# UNITED STATES PATENT AND TRADEMARK OFFICE

APPLICATION NO.	FILING DATE	FIRST NAMED INVENTOR	ATTORNEY DOCKET NO.	CONFIRMATION NO.
10/768,660	02/02/2004	Wiley Eugene Hill	H1501	8252
45114	7590	05/12/2005	EXAMINER	
HARRITY & SNYDER, LLP 11240 WAPLES MILL ROAD SUITE 300 FAIRFAX, VA 22030			NGUYEN, THINH T	
			ART UNIT	PAPER NUMBER
			2818

<b>Office Action Summary</b>	Application No.	Applicant(s)	
	10/768,660	HILL ET AL.	
	Examiner	Art Unit	
	Thinh T. Nguyen	2818

### **DETAILED OFFICE ACTION**

FIG.1

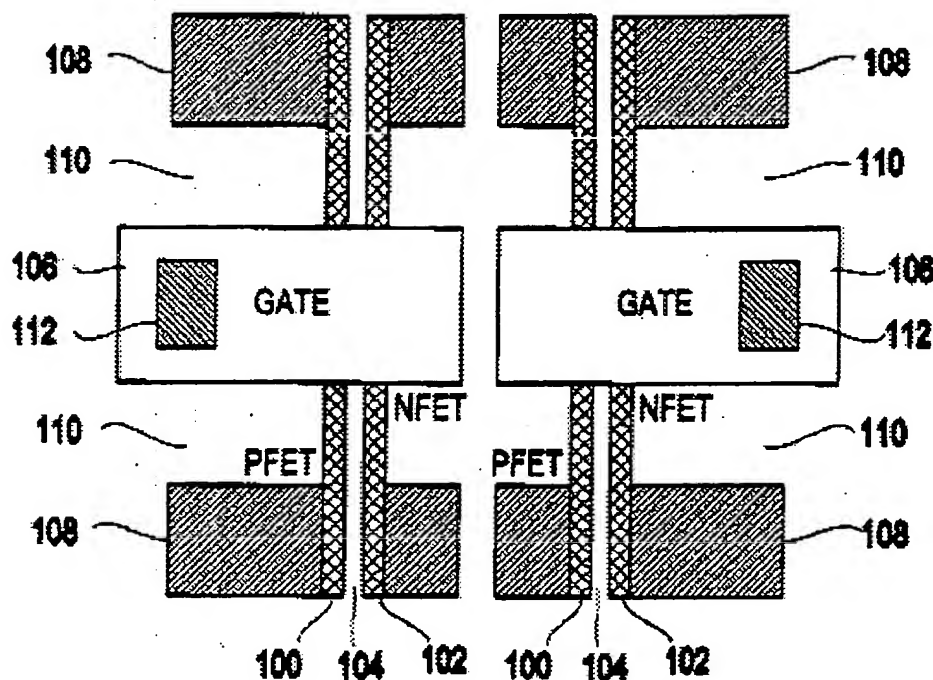
Bryant ( fig 1,the abstract, paragraph [0040] ) discloses a semiconductor device, comprising: a fin structure comprising a semi conducting material, the fin structure including a channel stop layer( fig 1 layer 104); a source region formed at one end of the fin structure, the channel stop layer separating the source region into a first source region ( fig 1 reference 108) and second source region; a drain region formed at an opposite end of the fin structure, the channel stop layer ( fig 1 layer 104) separating the drain region into a first drain region and second drain region; and at least one gate ( fig 1 layer 106).

Bryant ( fig 1, the abstract, paragraph [0040] ) discloses a semiconductor device comprising: an N-channel device including a first source region, a first drain region, a first fin structure ( fig 1 layer 100), and a gate ( fig 1 layer 106) ; and a P-channel device including a second source region, a second drain region, a second fin structure, and the gate, the second source region, the second drain region, and the second fin structure being separated from the first source region, the first drain region, and the first fin structure by a channel stop layer ( fig 1 layer 104).
